## Planning Commission Staff Report

**Meeting Date:** October 11, 2021

**Location:** 17909 & 17947 Chesterfield Airport Road

**Description:** **P.Z. 05-2021 Chesterfield Airport Service (17909 & 17947 Chesterfield Airport Road):** A request for a zoning change from “M3” Planned Industrial District and “PI” Planned Industrial District to a new “PI” Planned Industrial District for a tract of land totaling 1.005 acres located north of the intersection of Chesterfield Airport Road and Cepi Drive (17V520082, 17V520071).

Figure 3: Preliminary Development Plan

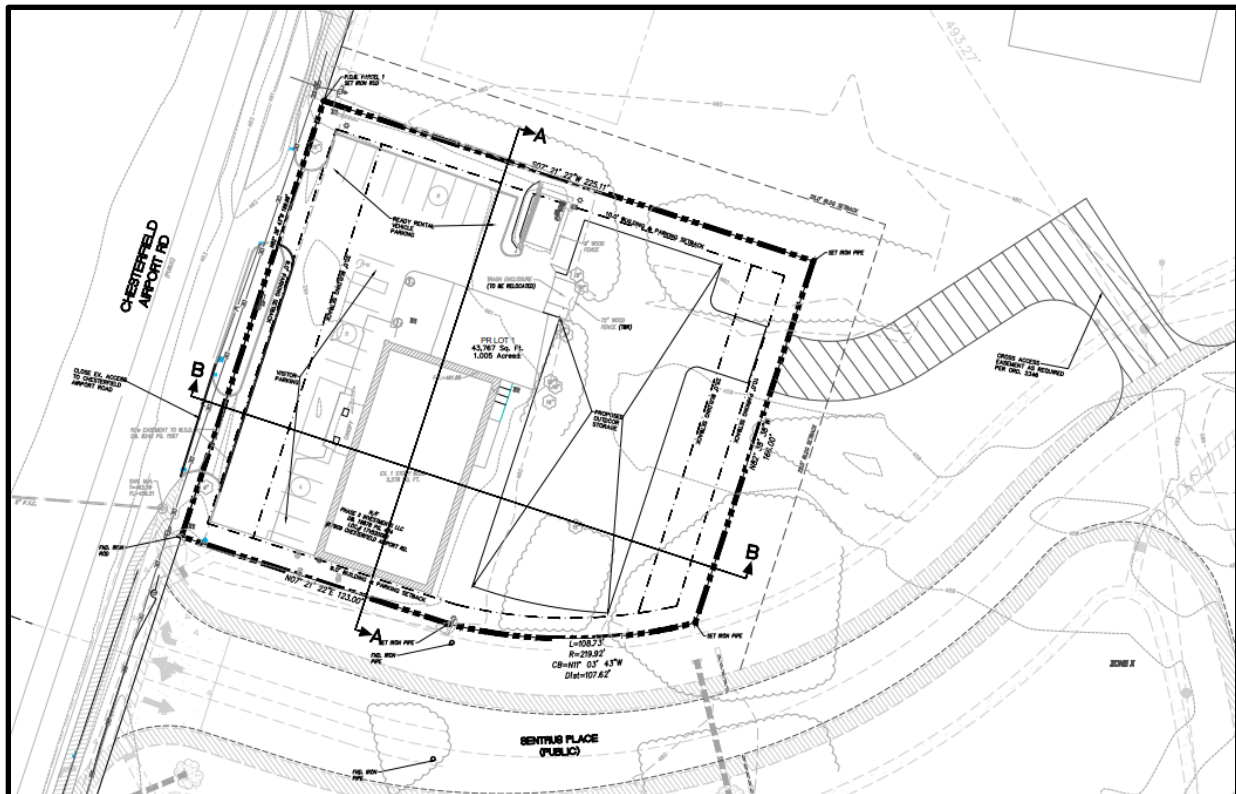
Issue: Planning Commission expressed concern that the proposed site did not have cross access to the proposed road Sentrus Place. Once the neighboring development of Sentrus Drive is developed, a roadway will be constructed along the eastern boundary of the subject property. Access to this future roadway should be accommodated in the Preliminary Development Plan.

Applicant Response: The applicant has revised the Preliminary Development Plan to ensure access to the future roadway. A cross access easement is now shown on the plan that aligns with the Sentrus Place approved Concept Plan.

*Staff has included language detailing the access requirement in the Draft Attachment “A” language for Planning Commission’s consideration.*

SHEET TITLE:  
**PRELIMINARY DEVELOPMENT PLAN**  
SHEET NO.:  
**C1.0**

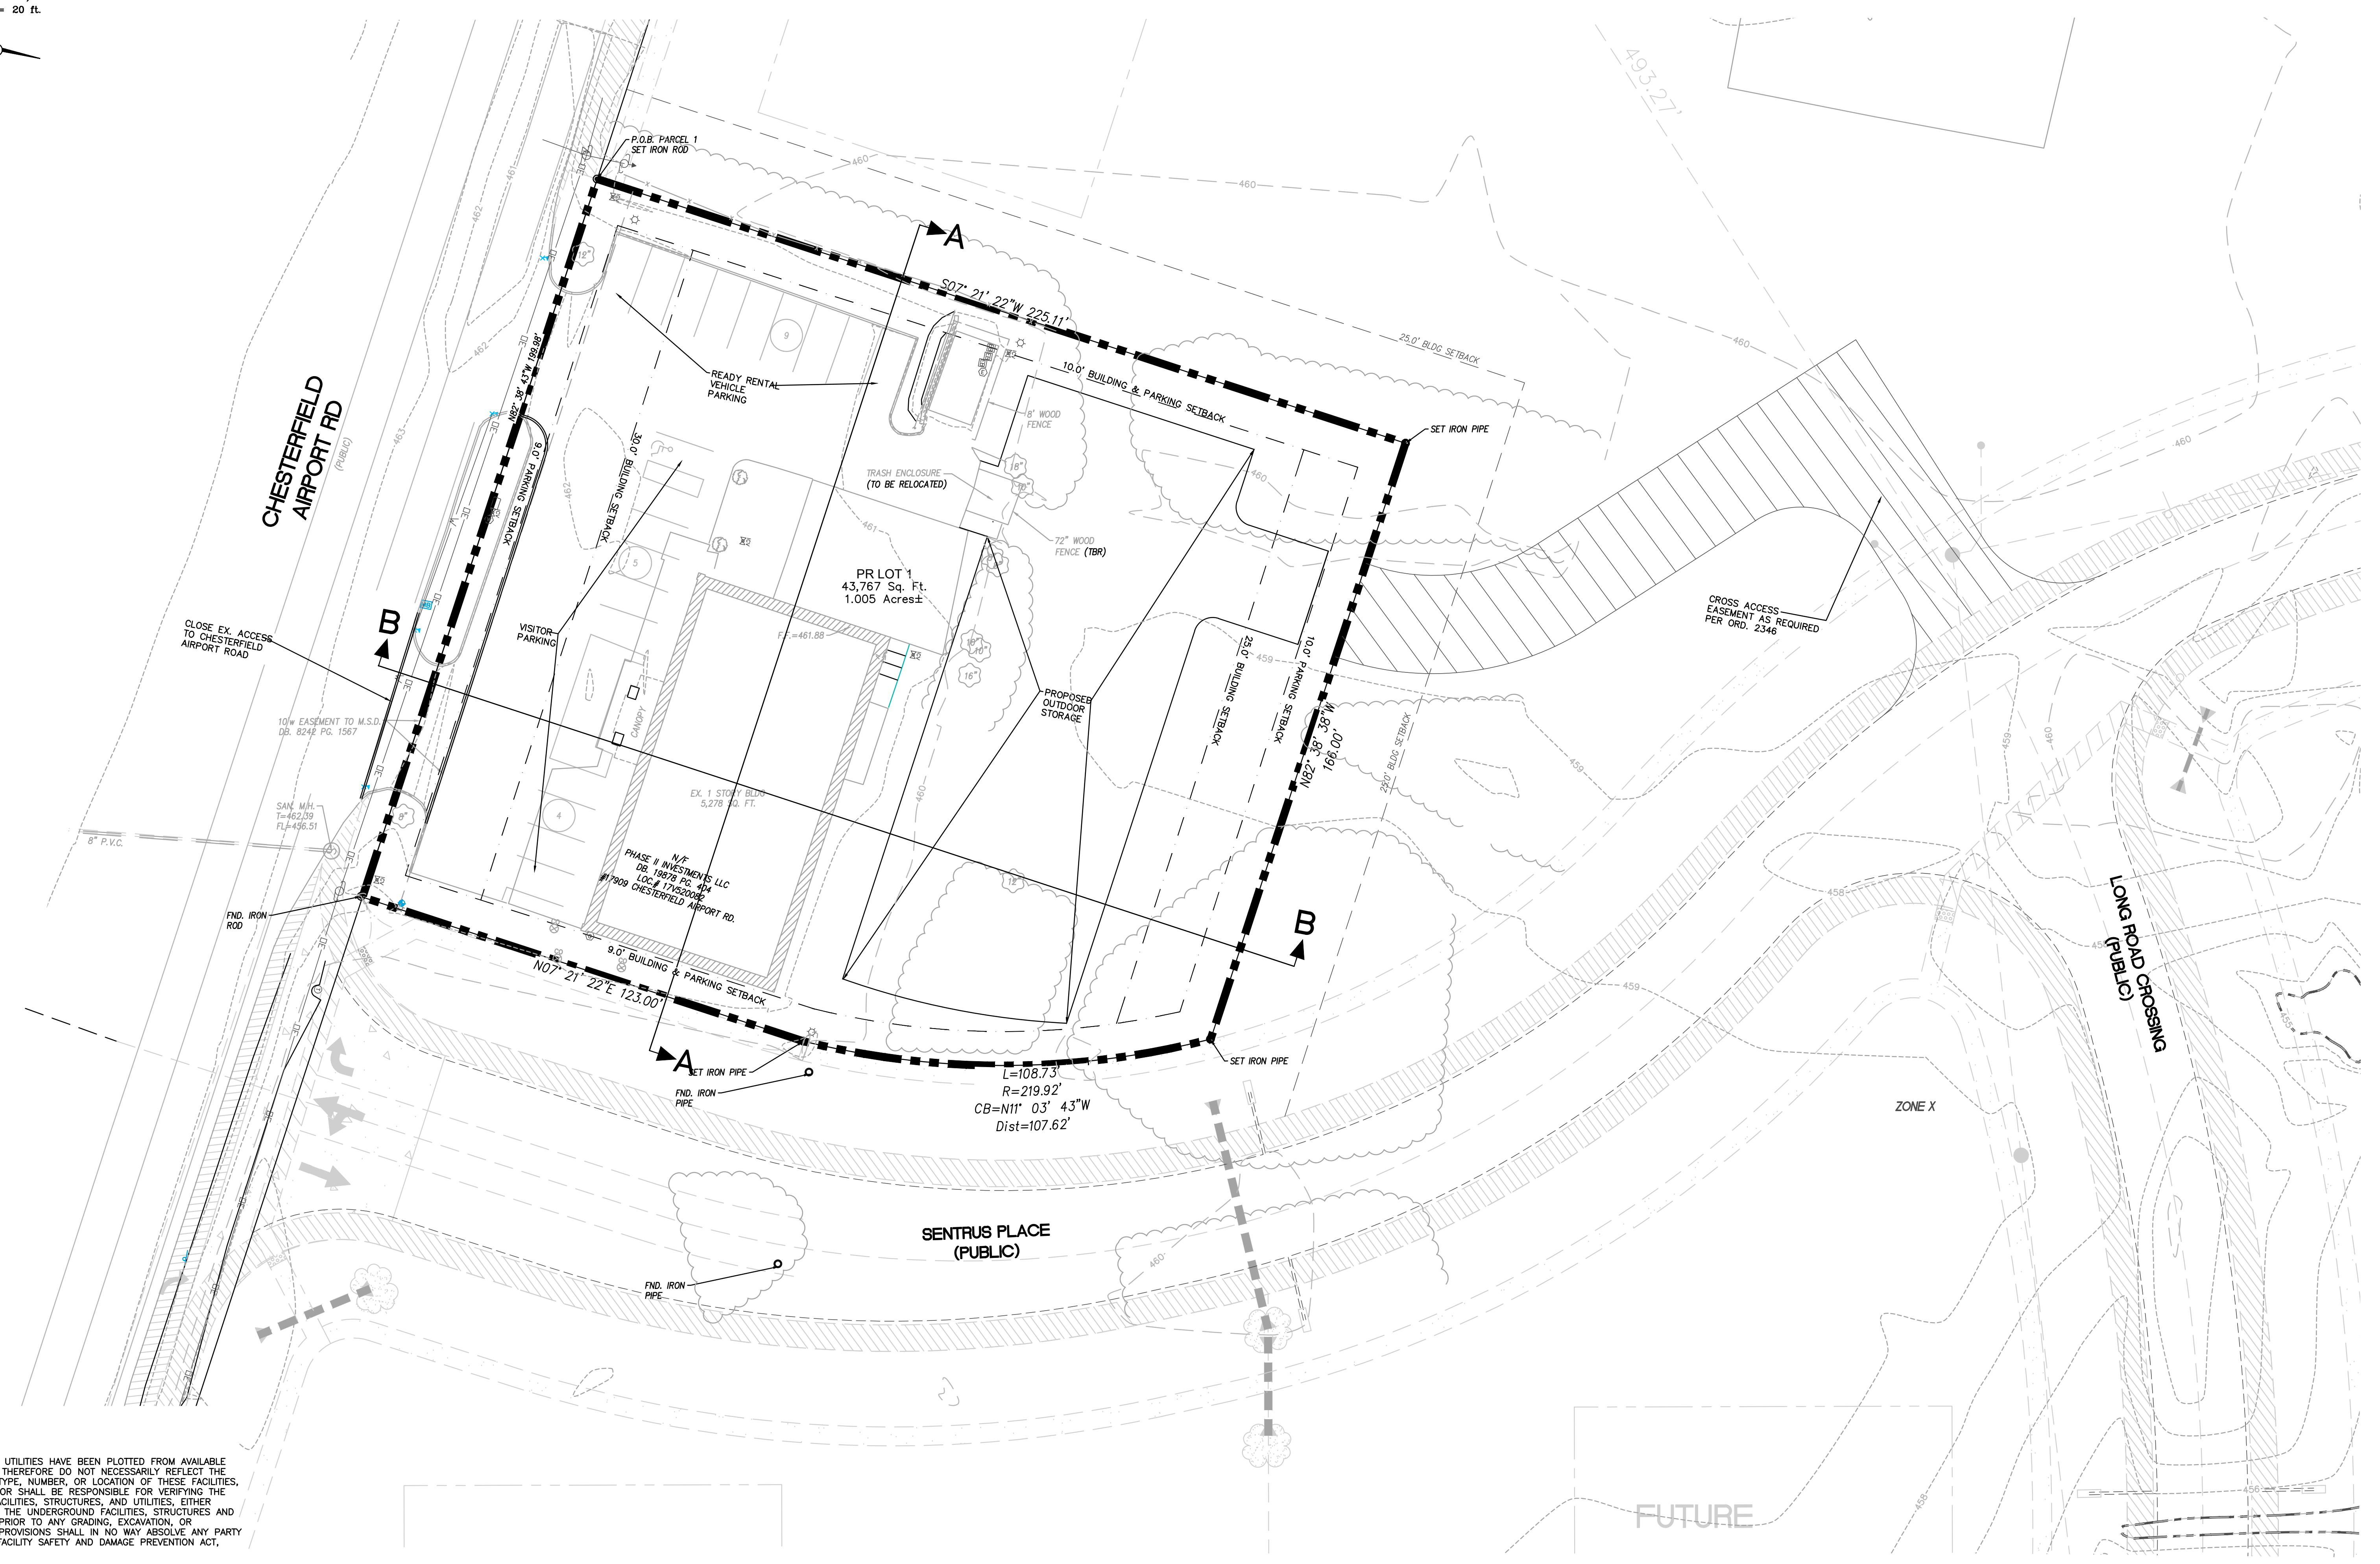
1. **Issue**—Consider revising the Preliminary Site Plan to accommodate future access to Sentrus Place.  
**Applicant Response:** Future access to Sentrus Place has been added to Preliminary Development Plan.
